**PROJECT NAME:** PINNACLE MONTESSORI ROCKWALL  
**EXISTING LEGAL DESCRIPTION:** LOT 5A, ROCKWALL BUSINESS PARK EAST  
**CASE NUMBER:** P2022-006  
**CURRENT OWNER:** BUFFALO COUNTRY PROPERTIES LLC,  
 ATTN: RAJESH MALVIYA  
 12050 RESEARCH ROAD, #9305  
 FRISCO, TX 75033  
**DEVELOPER:** SRC LAND BUILDING AND REAL ESTATE LLC  
 811 S. CENTRAL EXPRESSWAY, SUITE 306  
 RICHARDSON, TX 75080

MIS2025-005: Exception to the Residential Adjacency Standards at 950 E. Ralph Hall Parkway

## PLANNING AND ZONING COMMISSION MEMORANDUM

1: THREE (3) TIERED SCREEN; 2: CANOPY TREE; 3: TWO (2) ROWS OF EVERGREEN ACCENT TREES 20-FOOT OFFSET; 4: MINIMUM SIX (6) FOOT WROUGHT IRON FENCE; 5: CANOPY TREES 20-FOOT ON CENTER

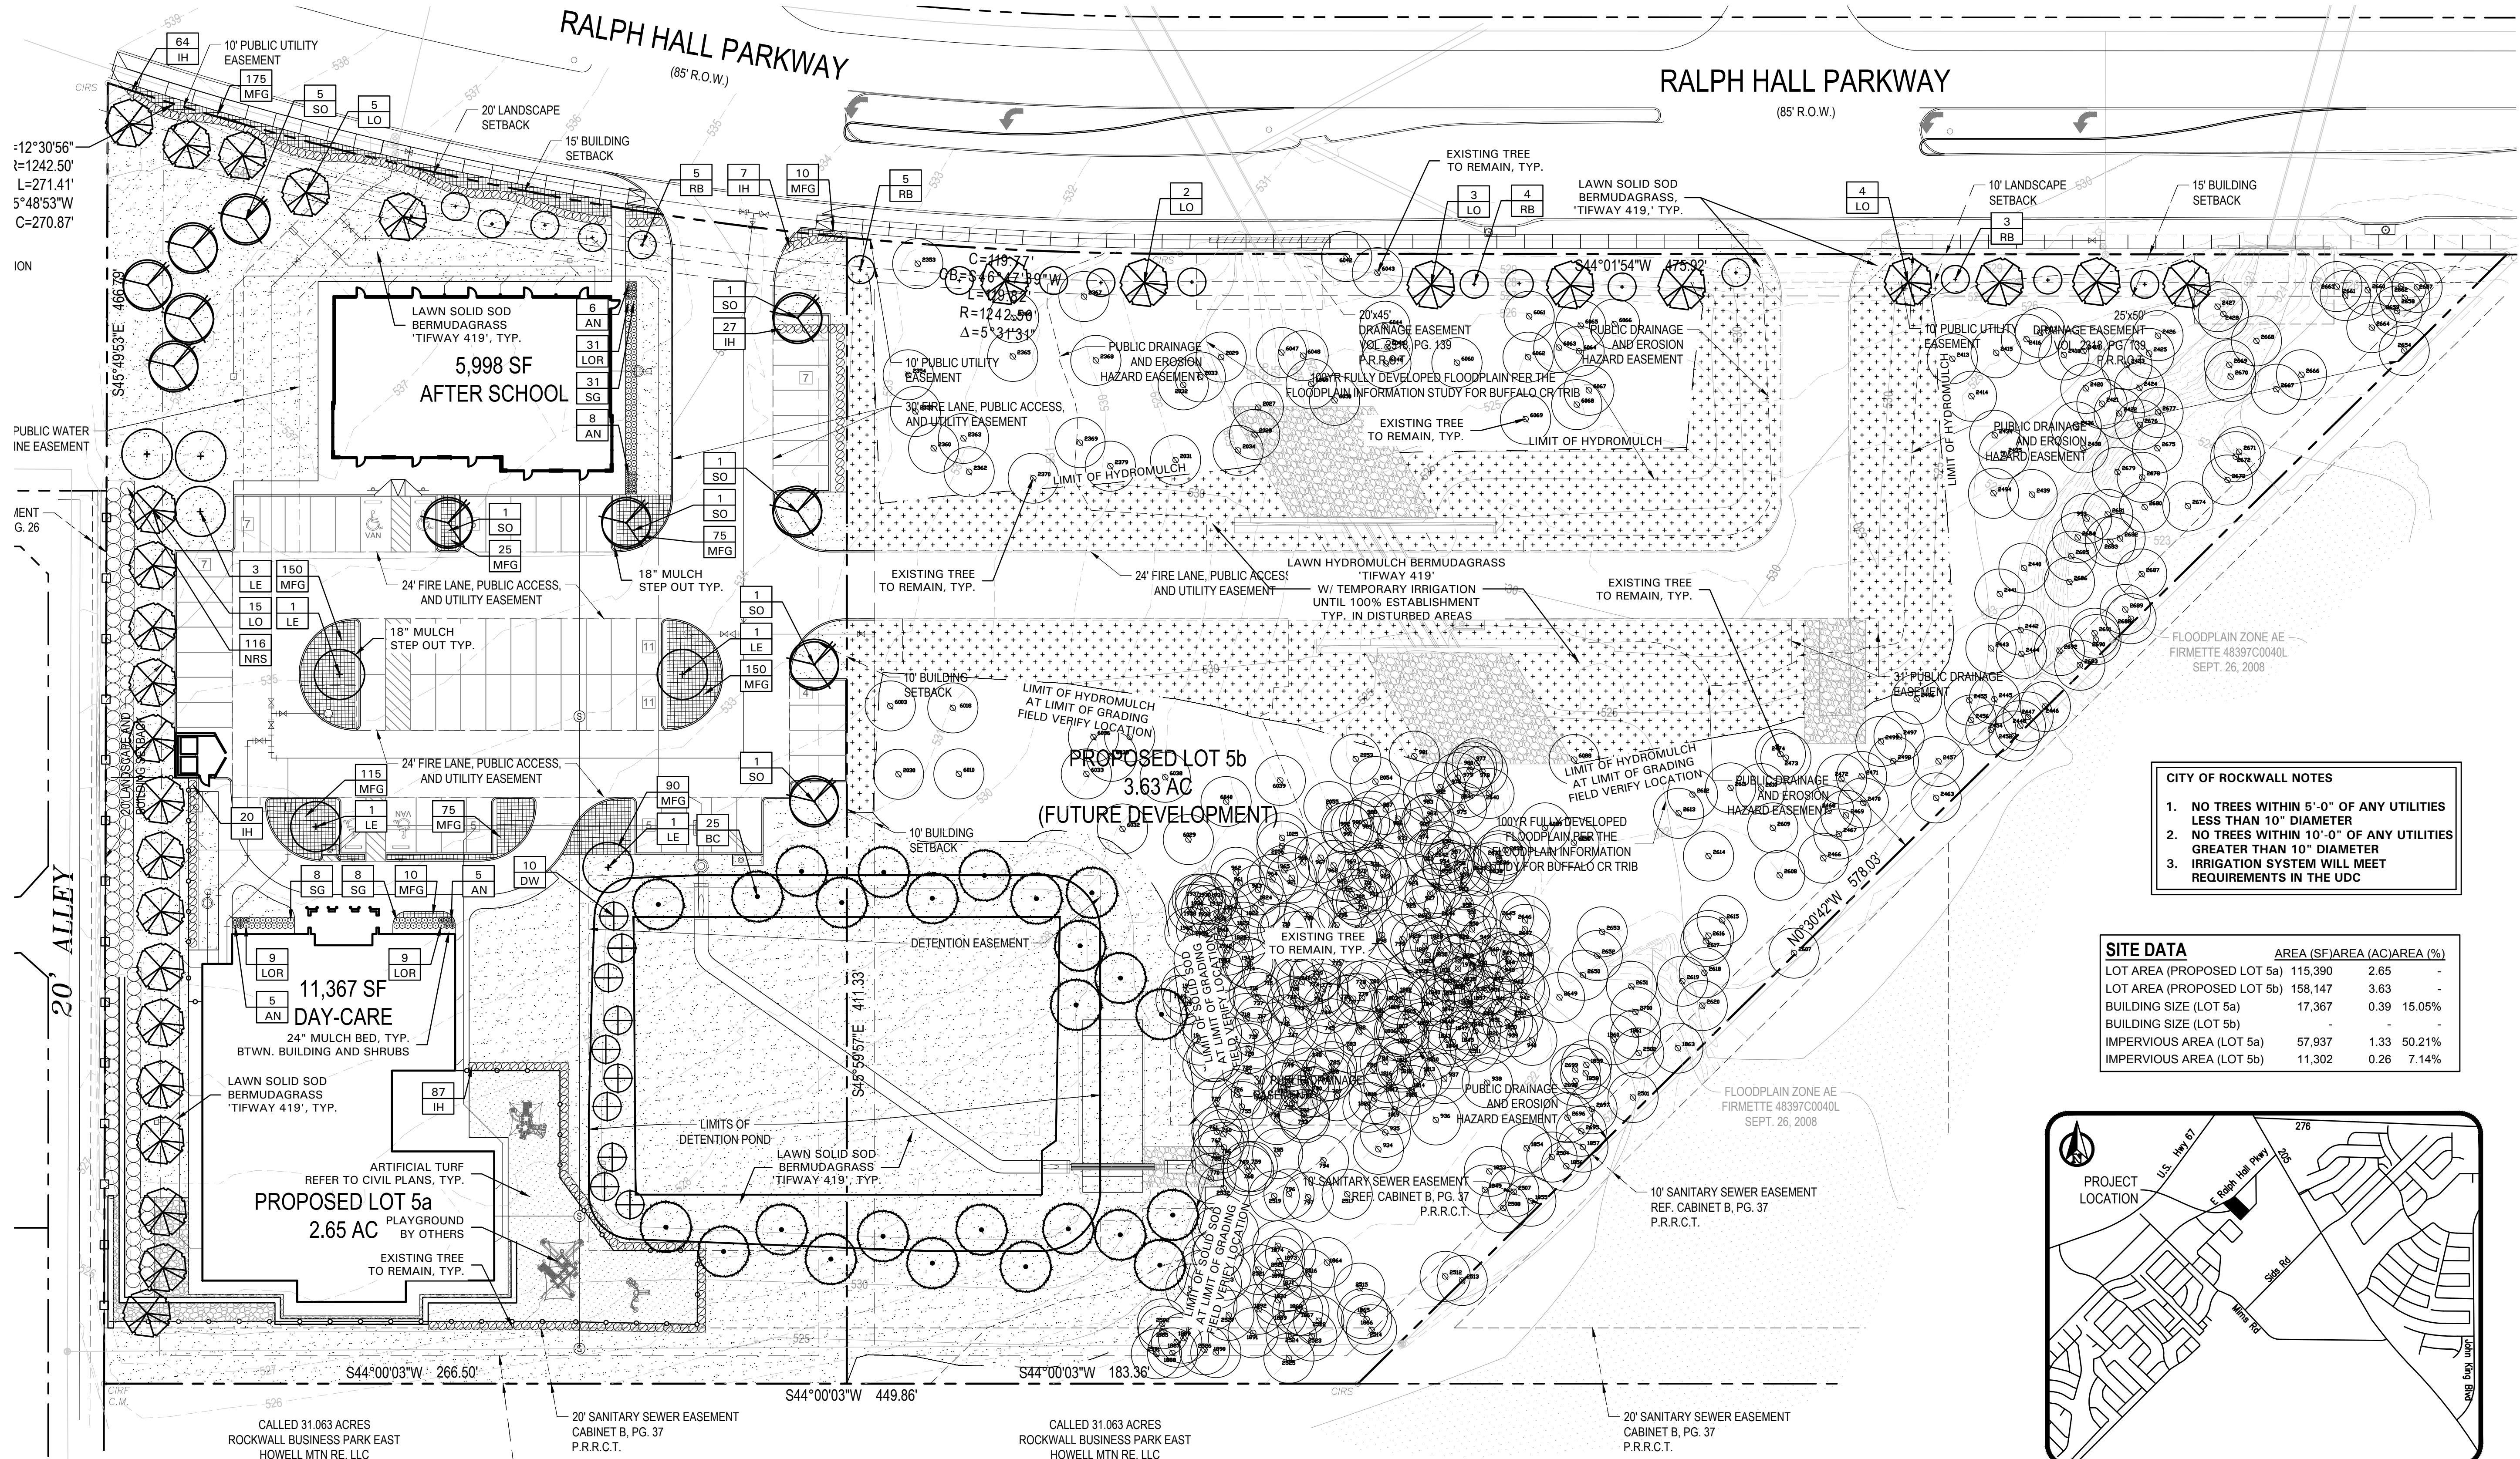
I.3 According to Subsection 05.02, Landscape Screening, of Article 08, Landscape and Fence Standards, of the Unified Development Code (UDC), "(a)ny non-residential or multi-family land use or parking area that has a side or rear contiguous to any residentially zoned or used property shall be screened with a masonry fence a minimum of six (6) feet in height with canopy trees planted on 20-foot centers." As an alternative the code does allow the Planning and Zoning Commission to consider the use of three (3) tiered landscaping along the adjacency. In this case, the applicant is providing three (3) tiered landscaping along the adjacency.

I.4 According to Subsection 09.01, Exceptions to the General Standards, "...an applicant may request the Planning and Zoning Commission grant an exception to the provisions contained in the Unified Development Code (UDC) where unique or extraordinary conditions exist or where strict adherence to the technical requirements of the Unified Development Code (UDC) would create an undue hardship." To request an exception the code goes on to require that a minimum of two (2) compensatory measures be provided for each exception requested. The purpose of the compensatory measures is to try to directly off-set the impact of requested exception. In this case the applicant has not provided any subsequent compensatory measures.

1.5 According to Subsection 08.02, General Fence Standards, "PVC mesh (i.e. tennis court mesh/windscreen) or other materials or appurtenances (e.g. slats, bamboo, mesh netting, fake or artificial plants or patterned material, signage, banners, etc.) intended to provide screening that are affixed to wrought iron, decorative metal, chain-link or semi-transparent fencing shall be prohibited."

**Figure 1:** Residential Adjacency Alternative #2

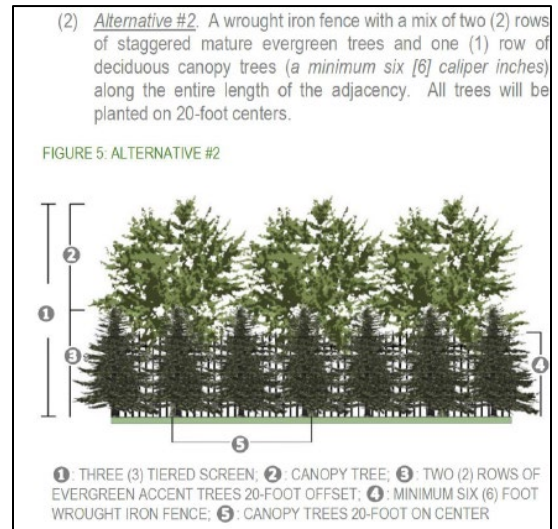
On March 14, 2025, the applicant – *Dyanada Nevgi of SRV Land Building and Real Estate, LLC* -- submitted a development application requesting the approval of an *Exception* to the residential adjacency standards for the purpose of allowing three (3)-tiered screening in lieu of the originally approved masonry wall. According to Subsection 05.02, *Landscape Screening*, of Article 08, *Landscape and Fence Standards*, of the Unified Development Code (UDC), “(a)ny non-residential or multi-family land use or parking area that has a side or rear contiguous to any residentially zoned or used property shall be screened with a masonry fence a minimum of six (6) feet in height with canopy trees planted on 20-foot centers.” However, the UDC does provide an alternative, allowing the Planning and Zoning Commission to consider the use of three-tiered landscaping in such cases. In this instance, the applicant is proposing three (3)-tiered landscaping along the entire length of the residential adjacency.

According to Subsection 09.01, *Exceptions to the General Standards*, “...an applicant may request the Planning and Zoning Commission grant an exception to the provisions contained in the Unified Development Code (UDC) where unique or extraordinary conditions exist or where strict adherence to the technical requirements of the Unified Development Code (UDC) would create an undue hardship.” The UDC further stipulates that a minimum of two compensatory measures must be provided for each exception requested to offset its potential impact. In this case, the applicant has not proposed any additional compensatory measures beyond the alternative landscaping method. The requested alternative for the use of three (3)-tiered landscaping along the adjacency does not appear to create a negative impact; however, exceptions are a discretionary decision for the Planning and Zoning Commission. In addition, exceptions require a supermajority vote (*i.e. a three-fourths vote of those members present*) for approval. Should the Planning and Zoning Commission have any questions concerning the applicant’s request, staff will be available at the meeting on March 25, 2025.
